## CERTAIN 2017 MODEL YEAR F-SUPER DUTY VEHICLES EQUIPPED WITH A 6.7L DIESEL ENGINE — TRANSMISSION FLUID COOLER TUBES REPAIR

FIGURE 1

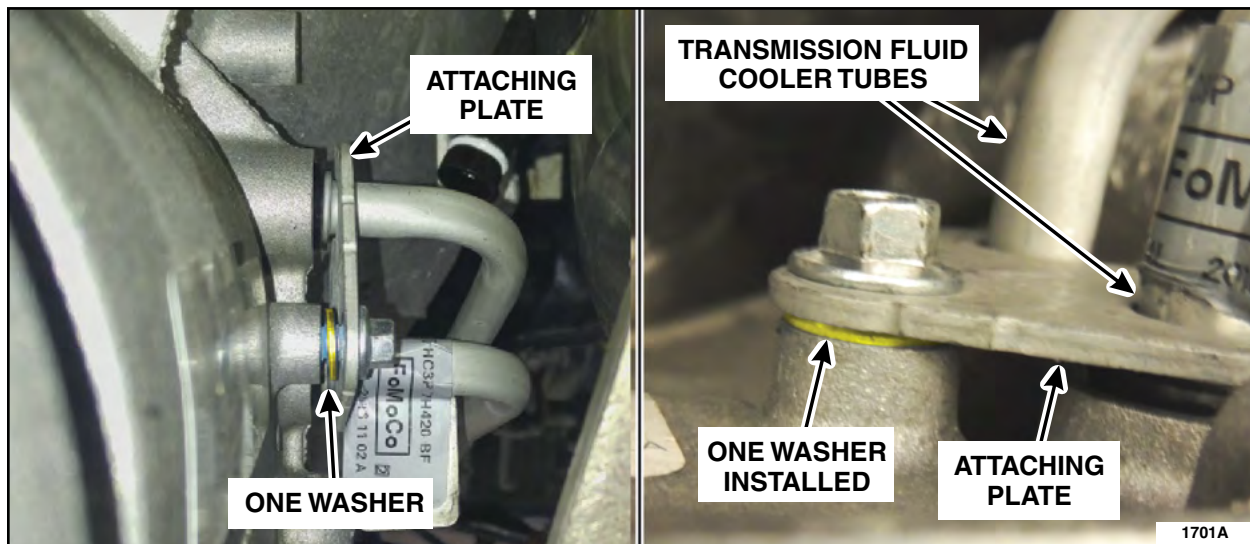
In some of the affected vehicles, a slow transmission fluid leak may occur due to the Transmission Fluid Cooler (TFC) tubes not being manufactured to the intended bend angle. This could cause stress loading, and ultimately cause a crack to form on the TFC tubes at the transmission, resulting in a leak. Customers may notice a small amount of fluid leakage on the ground and/or a service engine soon indicator illuminated in the instrument panel. If the leak progresses, customers could experience reduced engine function and hard transmission gear shifting. Dealers are to inspect the TFC tubes at the transmission for the presence of a leak. If no fluid leak is present, dealers are to install a washer behind the TFC tubes attaching plate, per the Technical Information, which will reduce stress loading of the TFC tubes. If a fluid leak is present, dealers are to replace the TFC tubes and install the washer as described above.

1. Inspect for the presence of a transmission fluid leak from the TFC tubes at the transmission.
  - If a transmission fluid leak **is** detected, proceed to Step 2.
  - If a transmission fluid leak **is not** detected, proceed to Step 3.
2. Replace the TFC tubes. Please follow the Workshop Manual (WSM) procedures in Section 307-02.
  - During installation, install a *new* washer between the transmission case and the TFC tubes attaching plate. See Figure 1.
3. Install a *new* washer behind the TFC tubes attaching plate.
  - a. Remove and discard the TFC tubes-to-transmission bolt.
  - b. Install a *new* washer between the transmission case and the TFC tubes attaching plate. See Figure 1.
  - c. Install the *new* bolt and tighten to 18 lb.ft (25 Nm).
